Access Compliance Report Public Rights-of-Way (Curb Ramps)

Main Street: N_FAIRBAIRN_ST Cross Street: BIXBY_AVE Location: NE

ADA ID: RPAT210924123345 Ramp Type: Type 1 - Perpendicular Initial Pass/Fail: Fail Overall Compliance: No Severity Score: 32

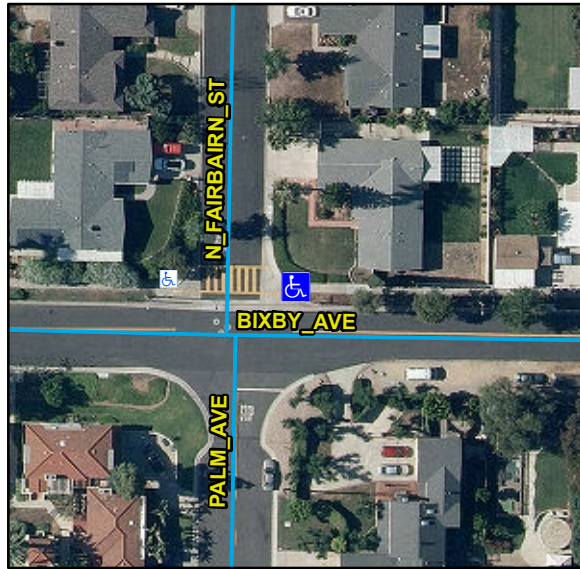
R204.3, R304.2.2, R304.5.3, STD 1115

Remove & Replace Entire Ramp. Restripe Crosswalk.
